寄件者: Chong Hermose [REDACTED]
寄件日期: 2026年06月27日星期六 14:34
收件者: tpbpd/PLAND
副本: Jason Sek Hei WONG/PLAND
主旨: s16 Planning application No. A/YL-SK/439 - 回應部門意見 (DSD)
附件: TEMPORARY DRAINAGE PROPOSAL_SK439_FULLSET.pdf

**TEMPORARY DRAINAGE PROPOSAL FOR THE PROPOSED TEMPORARY PLACE OF RECREATION SPORTS OR CULTURE (HOBBY FARM) AND ASSOCIATED LAND FILLING FOR A PERIOD OF 3 YEARS AT LOTS 1430 (PART), 1431 (PART), 1439(PART) AND 1440 (PART) IN D.D.114, SHEK KONG, YUEN LONG
A/YL-SK-439**

ISSUE 2 (June 2026)

Comments from Chief Engineer/Mainland North, Drainage Services Department (Contact Person:- Mr. Jeff TSE C.W., Tel: 3965 8921)

- NOTES:**
- HOARDING HEIGHT: 2500 mm
 - BOTTOM OPENING HEIGHT: 100 mm
 - OPENING WIDTH: 300 mm
 - OPENING EVERY: 2 m (CENTER TO CENTER)

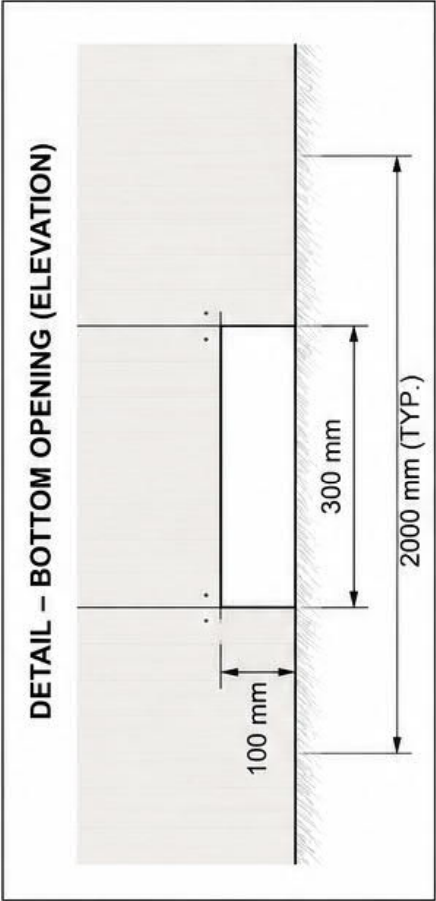
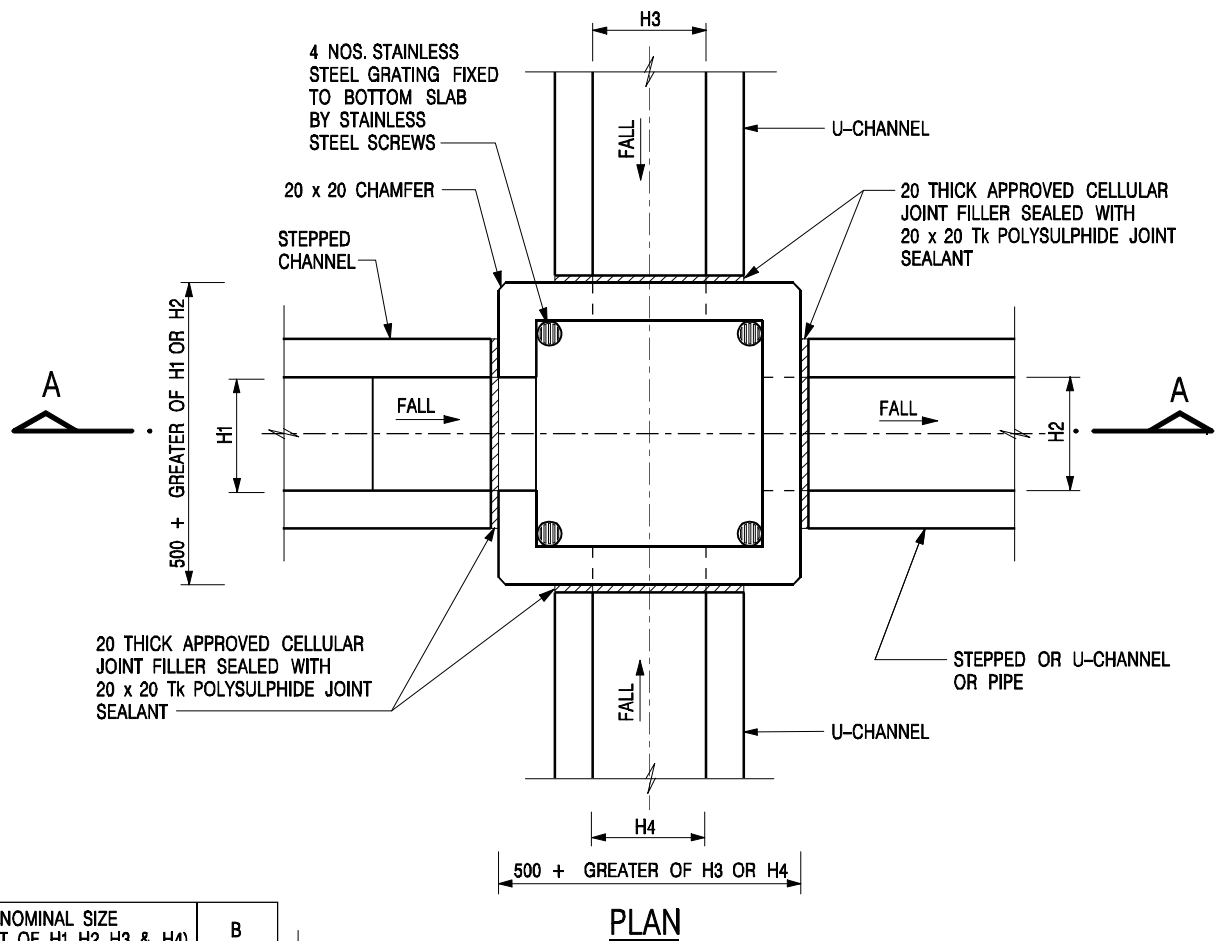
iv) According to cross section provided, it is noted that openings will be provided at the proposed fence. Please provide its details for comments and adequate opening/ gap should be provided to intercept the existing overland flow passing through the site.	Noted, drawing of the proposed fence with opening is attached in Appendix G.
